STPNOC Public Meeting with NRC to **Discuss STPNOC Risk-Informed GSI-191** Licensing Application **NRC Offices** Rockville, Md July 28, 2016

Overview of Expected Changes to Application

Follow-up RAI 34

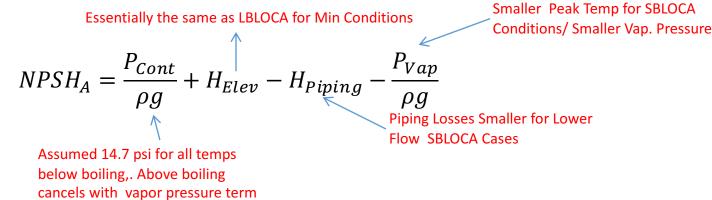
- Degasification/gas release for SBLOCA is bounded by LBLOCA
 - Head loss smaller for SBLOCA, and pressure difference causes gas release
- Consideration of plenum loss in CSHL calculation is conservative
- Integration of degasification and comparison to ½ height assumption
- A passing calculated void fraction was defined as a "void fraction less than 2% with non-boiling conditions in the pool".
 - Cases that used Reg. Guide 1.82 to credit overpressure but resulted in nonzero void fraction less than 2% did so to prevent failing NPSH conditions at the pump; ie if boiling is present in the pool or void >2%, a passing NPSHm cannot be achieved because of forced cavitation.
 - Vertical pump design provides margin
